**SUNDRY NOTICES AND REPORTS ON WELLS**  
*Do not use this form for proposals to drill or to re-enter an abandoned well. Use form 3160-3 (APD) for such proposals.*

8. Well Name and No.  
EMPIRE ABO UNIT 018A

9. API Well No.  
30-015-00706

**Empire Abo Unit 018A  
30-015-00706  
Apache Corporation  
December 07, 2016  
Conditions of Approval**

## Wellbore Diagram – Current Status

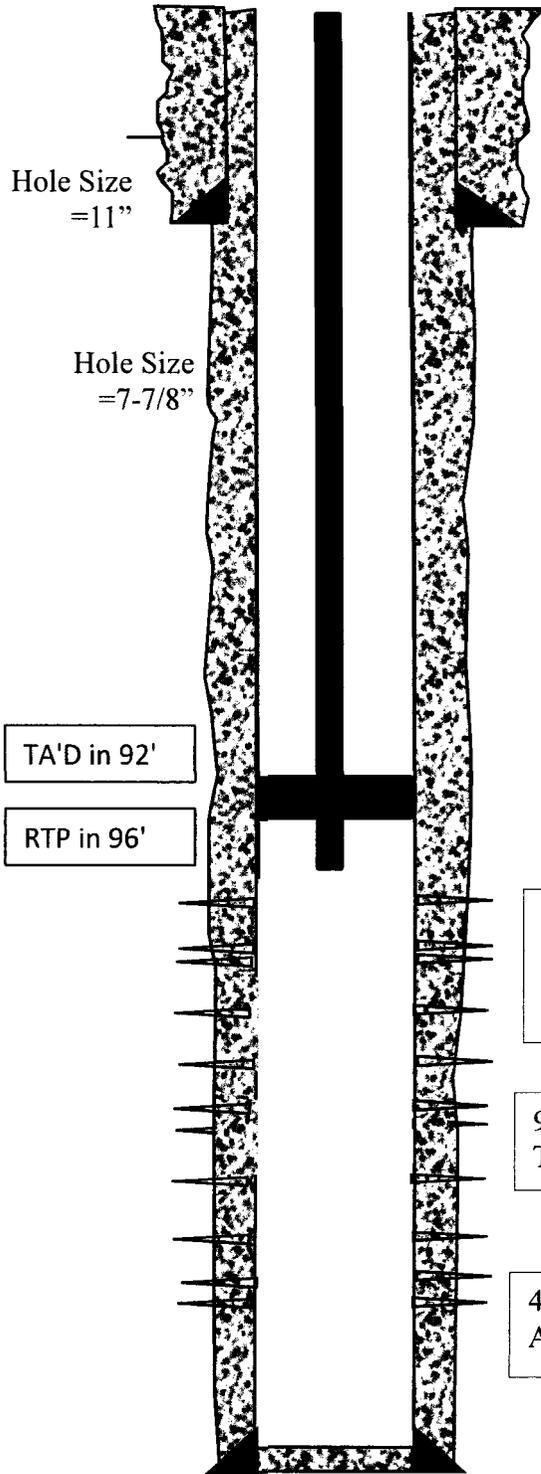
- 1. Squeeze approved as written.**
- 2. Must conduct a casing integrity test before perforating and fracturing. Submit results to BLM. The CIT is to be performed on the production casing to max treating pressure. Notify BLM if test fails**

- 9. Subsequent sundry required detailing work done. Operator to include well bore schematic of current well condition when work is complete.**
